ARCHITECT'S SUPPLEMENTAL INSTRUCTIONS

Table with project details: PROJECT: Residence at Heritage West, OWNER: OPG Heritage West Partners, LLC, CONTRACTOR: MCP Build, Report No. Seven (7), Date August 12, 2025, Architect's Proj No. 24-3379, Contract For: General Construction Mechanical, Electrical

REVISION:  
 ASI #7\_8-12-2025

**A FIRST FLOOR PLAN**  
 3/32"=1'-0"

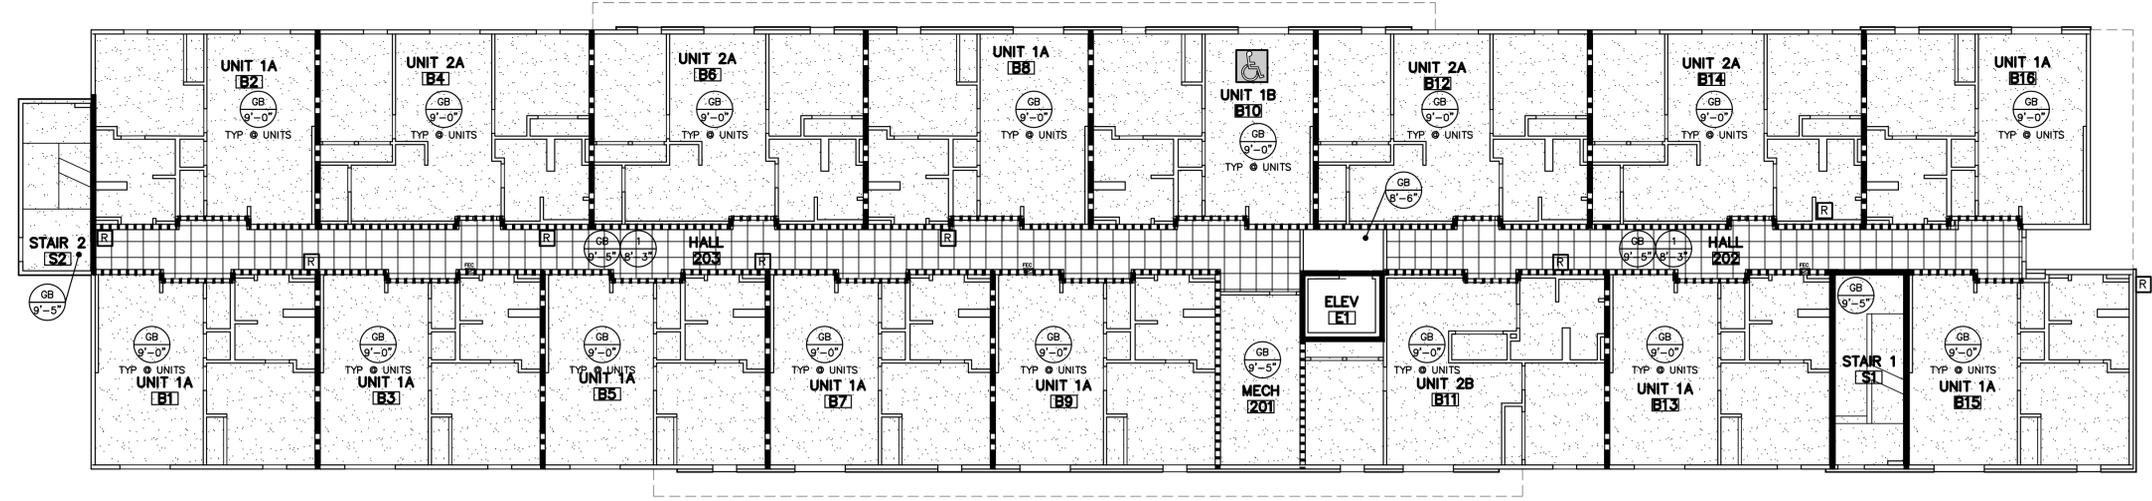
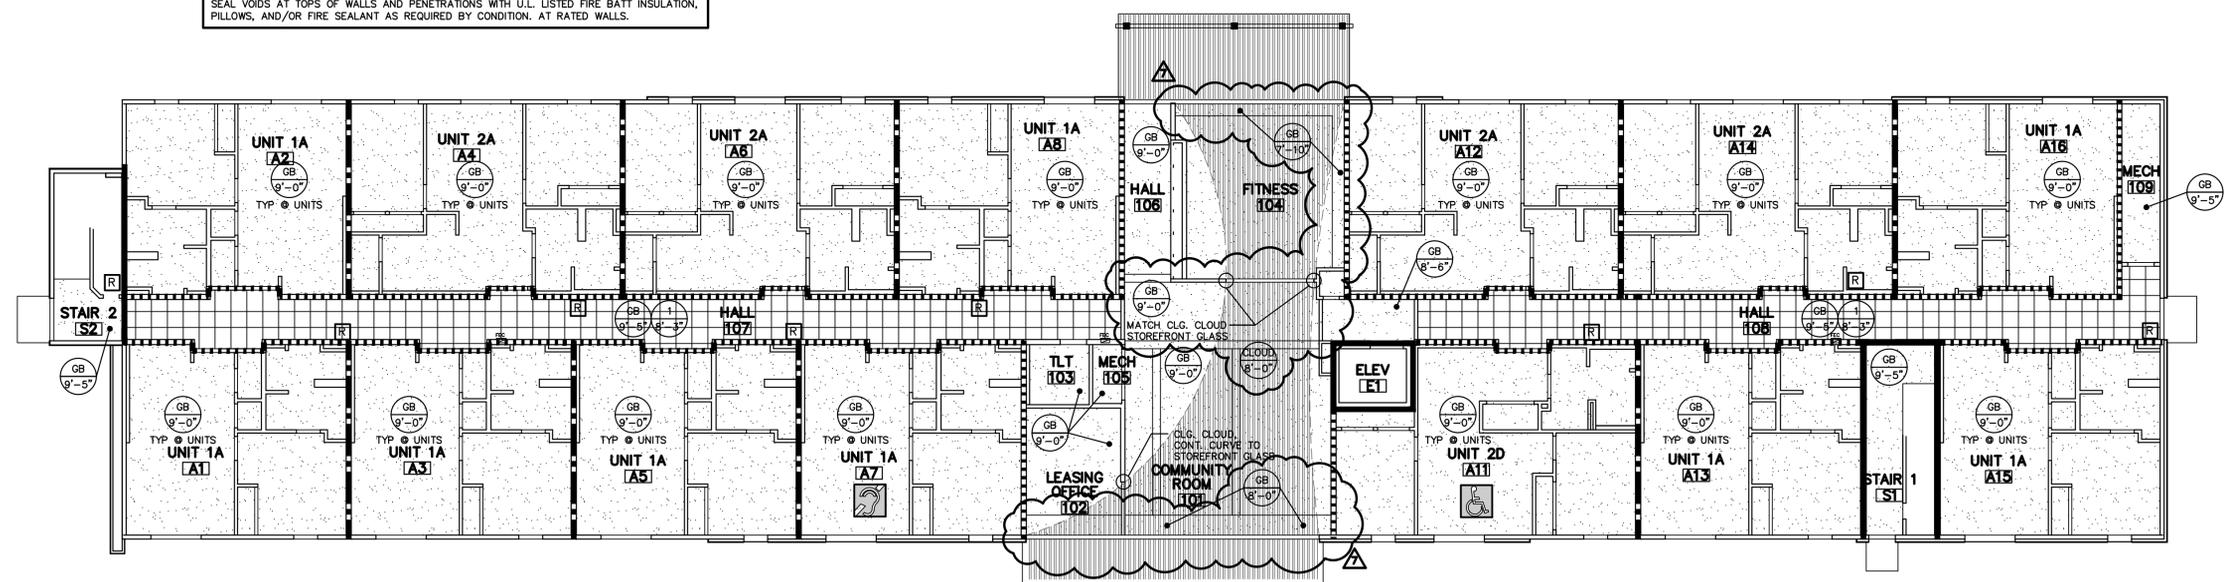
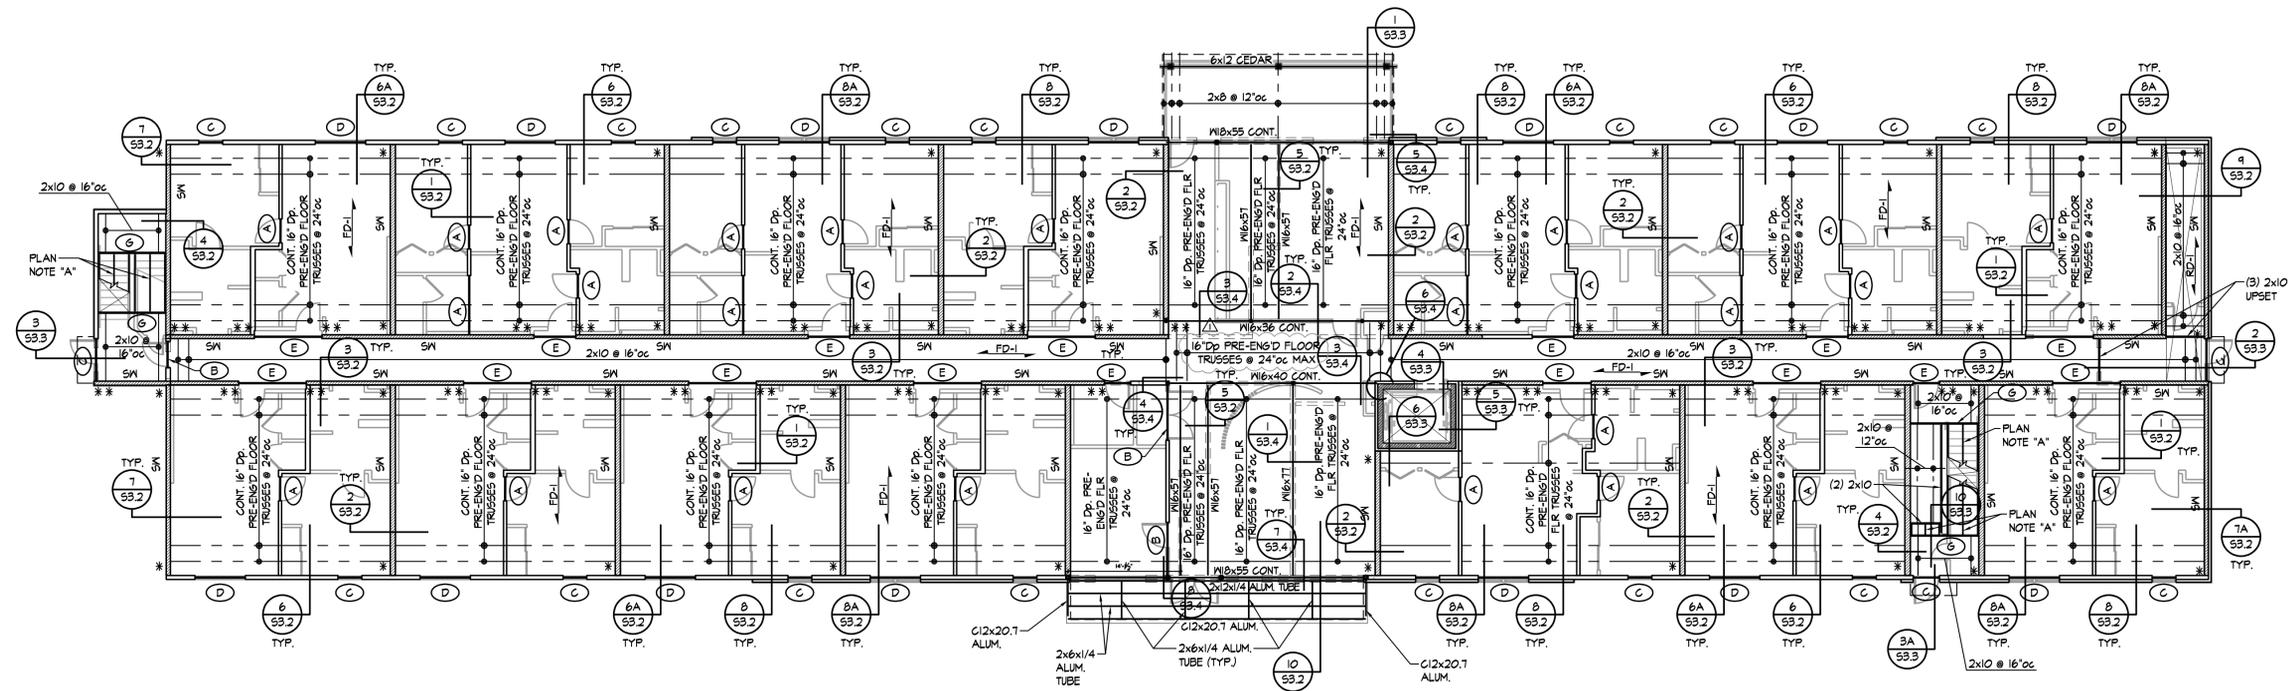
New gyp. bd. framed soffits shall be framed as indicated on A7.1 in response to the adjusted HVAC duct routing per updated MEP sheets over community room, leasing office, and fitness rooms. These soffits are to accommodate the HVAC duct sizes as shown. All other gyp. bd. ceilings over the common spaces should be at 9'-0 typical as allowable.

Ceiling cloud as shown on A7.1 will be hung from floor/ceiling joists and will be as proposed by owner.

**SECOND FLOOR FRAMING PLAN**

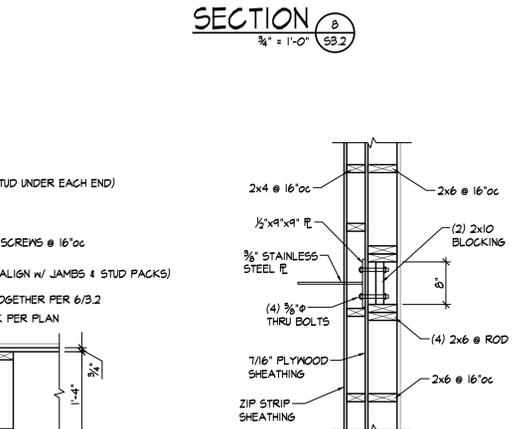
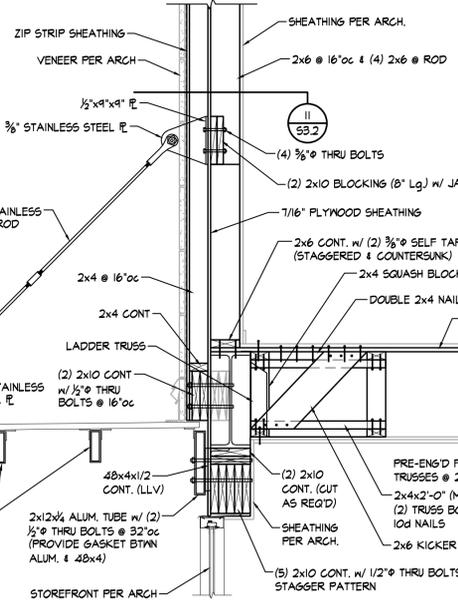
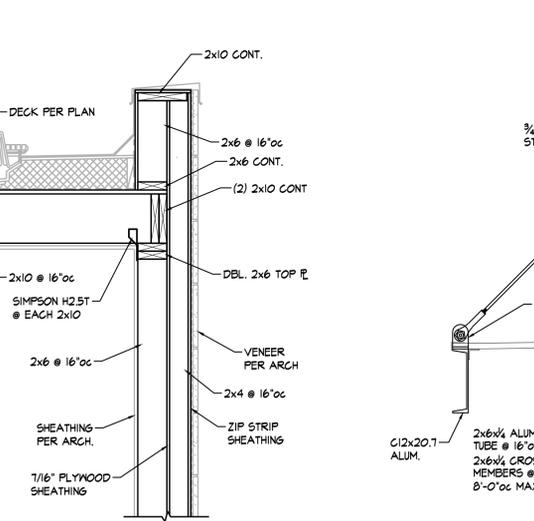
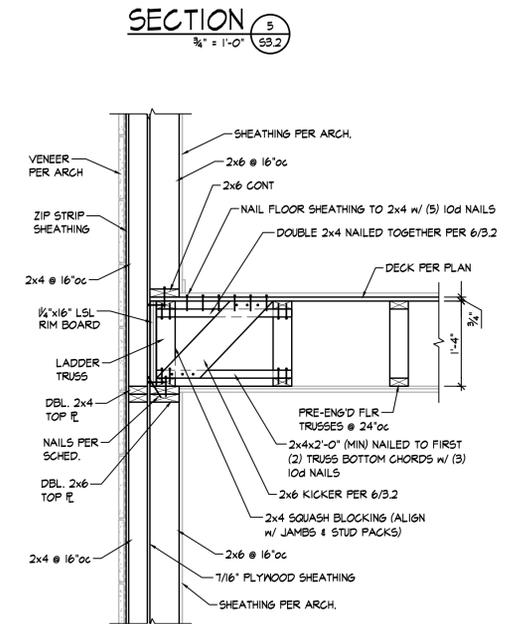
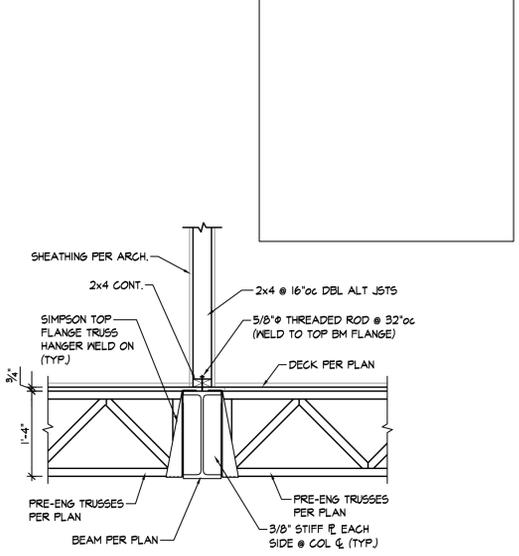
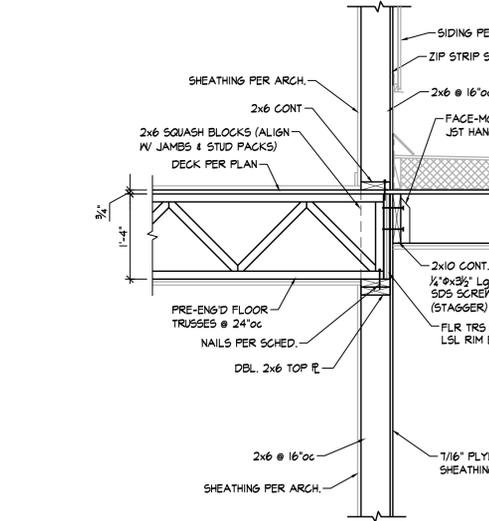
The common area floor/ceiling trusses have been modified at the central corridor on floor 1 to accommodate the HVAC ductwork and maintain a ceiling height of 9'-0. The 2x10 joists have been changed to be 16" deep typical floor trusses spanning this section of corridor. HVAC ducts will be located within the truss spaces and not below joists as previously designed. The HVAC ducts will be routed down under the remaining 2x10 joists down each corridor direction away from the common area.
